Service Bulletin

S.B. No: 152

Title: AIRBORNE ILS (LOCALISER) VOR AND VHF COMMUNICATIONS - IMPROVED FM BROADCAST INTERFERENCE IMMUNITY STANDARDS/PLACARDING

Placard Part No. T67B-83-844

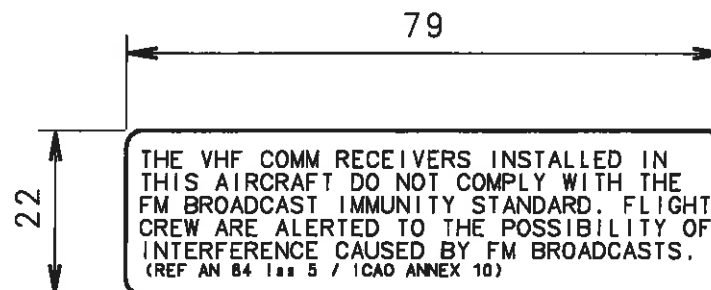
1. VHF ILS Localiser/VOR receiving equipment:

The placard is as below:

The fitting of this placard invokes SAL Mod M946A. Annotate log book "AWN 84 Issue 5 complied with and Mod M946A incorporated" if applicable.
